# WARRANTY BULLETIN SAFETY CAMPAIGN

Can-Am® On-Road Spyder™

Campaign no.: 2022-0019

**February 9, 2023** Subject: **Rearview Mirror Lenses May Dislodge - Decreased Visibility** No. **2022-19**

### MIRROR HOUSING ASSEMBLY REMOVAL

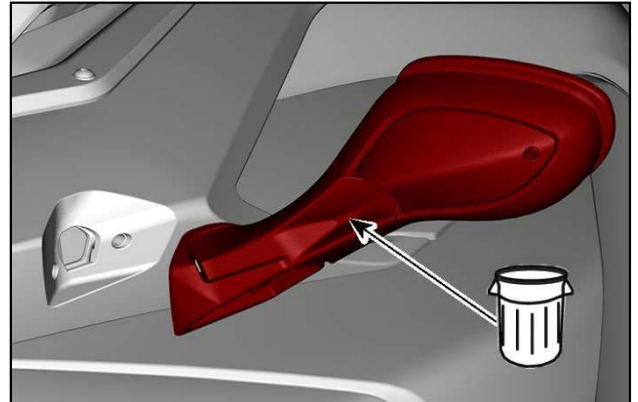
1. Remove and discard the two housing retaining screws.

2. Discard the mirror housing assemblies.

3. Clean threads on vehicle.
